Proposed Bonneville Washington Shore Fish Ladder Count Station Modifications to Improve Pacific Lamprey Passage

FPOM
21 December 2010
Sean Tackley (503-808-4751)

US Army Corps of Engineers Portland District

PLAN G EXIT CONTROL SECTION
AND COUNTING STATION
BRADFORD ISLAND FISH LADDER

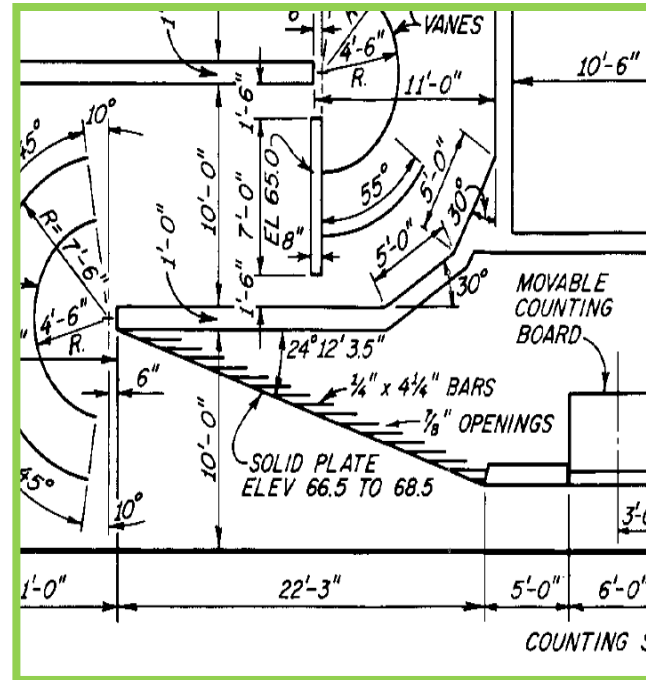
Upstream picket lead sections to be modified

Downstream picket lead section to be modified

Picket lead lamprey ramp to be installed

Bonneville WA Shore Count Station Modifications: Reduce Spacing and Bar Thickness of Upstream Picket Leads

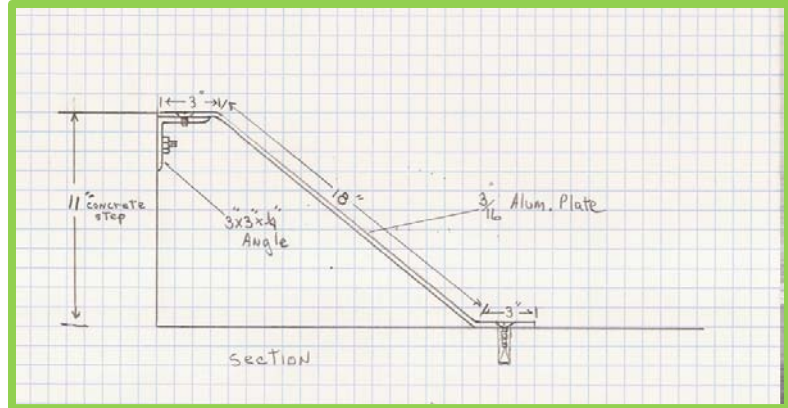
- Modify or replace 4 upstream picket lead sections
- Each section is 60" x 42"
- Spacing will change from 7/8" openings to 5/8" openings
- Bar thickness will change from 1/4" to 1/8"

Bonneville WA Shore Count Station Modifications: Install Picket Lead Lamprey Ramp

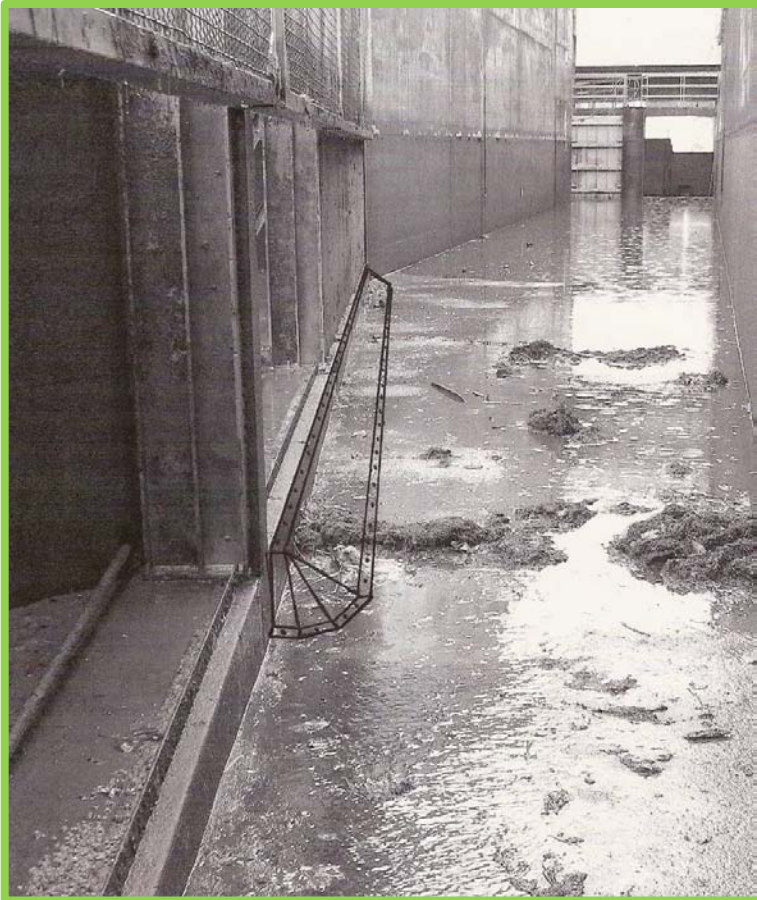
- Ramp covers concrete sill (~11") at base of picket leads, downstream of count station
- All joints and end closures will be field fit welded and ground smooth
- All fasteners are stainless steel and countersunk
